Access Compliance Report

Public Rights-of-Way

Intersection ID: 12027	Main Street: S_SUMMIT_AV	Cross Street: W_MOREHEAD_ST	Location: SW
ADA ID: 5B39F287E568	Ramp Type: Perp	Initial Pass/Fail: Fail	Overall Compliance: No
		Severity Score: 8.75

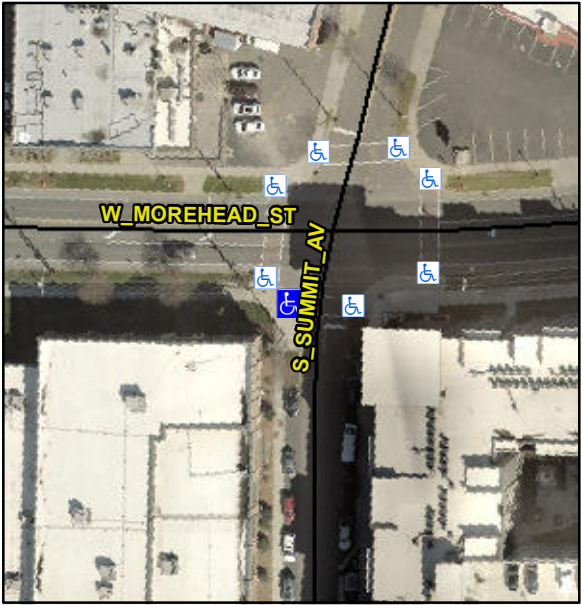
Codes/Mitigation Info/Possible Solution		Field Measurements/Component Compliance			
	Possible Solutions:				
	Remove & Replace Entire Ramp.				
	Surveyor Notes:				
	N/A				
	PROW/ADA:				
	R304.5.1				
Street 1 Name	SUMMIT AV				
Stop Condition-Street 2	StopSign				
Street 2 Name	N/A				
Stop Condition-Street 1	N/A				
Total Cost:		\$	1850.00

Compliance	Description	Data	Compliance	Description	Data
N/A	Ramp Length (in)	89.5	Yes	Ramp Slope (%)	7.2
No	Ramp Width (in)	47.5	Yes	Ramp XSlope (%)	1.0
N/A	Flare Type LT	N/A	N/A	Flare Type RT	N/A
N/A	Flare Slope LT (%)	N/A	N/A	Flare Slope RT (%)	N/A
N/A	Flare Traversable LT?	N/A	N/A	Flare Traversable RT?	N/A
N/A	Landing Length (in)	N/A	N/A	DWS Provided?	N/A
N/A	Landing Width (in)	N/A	N/A	DWS Contrast?	N/A
N/A	Landing Slope (%)	N/A	N/A	DWS Length (in)	N/A
N/A	Landing X Slope (%)	N/A	N/A	DWS Full Width?	N/A
N/A	Landing Curb? (Y/N)	N/A	N/A	DWS Offset (in)	N/A
N/A	Shared Landing?	N/A			
N/A	Gutter Ponding?	N/A	N/A	Gutter Slope (%)	N/A
N/A	Gutter Lip Ht (in)	N/A	N/A	Gutter X Slope (%)	N/A
N/A	Painted X Walk1?	Yes	N/A	Painted X Walk2?	N/A
	X Walk 1 Direction	To E		X Walk 2 Direction	N/A
N/A	X Walk 1 Width (in)	104.0	N/A	X Walk 2 Width (in)	N/A
	X Walk 1 Slope (%)	2.9		X Walk 2 Slope (%)	N/A
	X Walk 1 X Slope (%)	0.5		X Walk 2 X Slope (%)	N/A
